MEMORANDUM

From:	Built Heritage Officer	Service:	Green Infrastructure
Application No.	252048 + 252049	Site Visit Made:	Yes
Address:	Waitrose Ltd, Rectory Road, Wokingham, RG40 1BB.		
Proposal:	252048 - Application for submission of details to comply with the following conditions of planning consent 241915 dated 29/10/2024. Condition 3 relates to details of the works and condition 4 to walling stability. 252049 - Application for submission of details to comply with the following conditions of Listed Building consent 241916 dated 28/10/2024. Condition 3 relates to CM9 walling stability and condition 4 to details of works.		
Relevant built heritage condition text.	<u>252048 & 252049: Condition 3.</u> Prior to the commencement of works hereby approved the following details shall be submitted to and approved in writing by the local planning authority and shall be implemented as so approved. a) Details and a sample of the lime mortar to be used, including confirmation of the pointing finish to be used. b) Details and sample of the bricks and mortar to be used for the construction of the buttresses and the return walling to the end of the wall H1. c) Scaled profile drawing at 1:5 or 1:10

Extract below from the approved drawing 25317-01 P6 from 241915 & 241916, which shows new end wall and buttresses brickwork keyed into the H1 walling

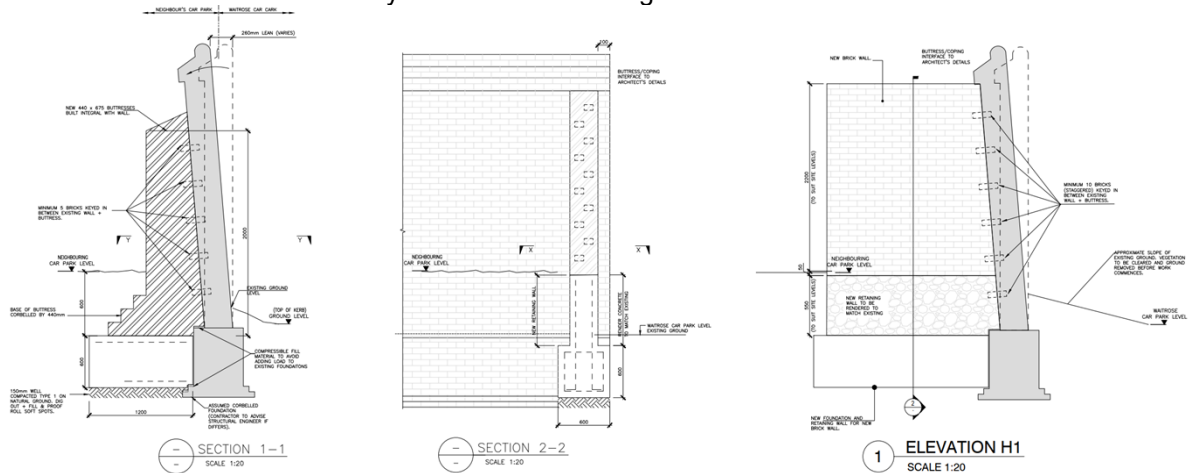
Summary Of Recommendations
Condition 3a - acceptable details provided for condition to be discharged. Condition 3b - mortar mix and re-pointing finish details provided are acceptable for condition 3b. to be discharged in-part. Whilst the bricks to be used for the new walling and to cover the buttresses are acceptable there is however concern due to the size as to whether they can be used to key-in with the existing walling. Condition 3c - acceptable details provided for condition to be discharged. Condition 4 – acceptable details provided for condition to be discharged.
Comments
Additional comments to those initially made on 15/10/25 (in response to the originally submitted material) and to the emailed comments of 20/11/25 (in response to the lime mortar mix/re-pointing finish + additional drawings) Additional Information: - Email dated 22/10/25 from case officer -confirming mortar mix & re-pointing finish. Include also revised drawing 25317-01 P8 with additional details to protect the bricked in arch during repair works. Drawing 25317-03 (Existing Elevations) previously submitted for 241915 / 241916 provided again with respect to the profile for the rebuilt top sections of the existing wall. - Email dated 28/11/25 from case officer, which included applicant information on the matter of the existing top portion of walling and suggested form to be rebuilt to. 10/12/25 Physical sample of bricks and mortar mix to be used. Whilst the details submitted to comply with condition 4 of 241915 and 241916 are considered acceptable to allow this condition to be discharged in full, there is a requirement for further details for condition 3. 3a. - the details for the lime mortar, the physical sample and stated re-pointing finish are considered acceptable for the condition to be discharged in full. 3b. - the sample of the bricks to be used for the construction of the buttresses and the return walling to the end of the wall H1 are in principle acceptable albeit it was noted they are of a different size/larger than those of the existing walling, which would mean the coursing of the brickworks of new end walling will not align with that of the existing walling's brickwork. Whilst not necessarily believed to be a reason in itself for the chosen brick to be rejected they larger size (and the leaning orientation of the historic wall) would suggest a potential issue in using these bricks to key in with the small bricks used in the historic wall. As such, would advise not fully discharging condition 3b. without first obtaining further details from the applicant that are then found to be acceptable in terms of the use of those bricks and whether using them will require modifying the existing brickwork of the historic wall beyond cutting out of brick to provide the point to key in the new bricks? 3c. With respect to the approach set out by the applicant set out in the email dated 28/11/25 for the topmost part of the historic across its length to be rebuilt to that shown in Section 3-3 of drawing no. 25317-03 P2. Here whilst having the half round coping brick

would perhaps be more ideal in visual and run off terms. That said the Section 3-3 would be overall acceptable for the condition to be discharged.
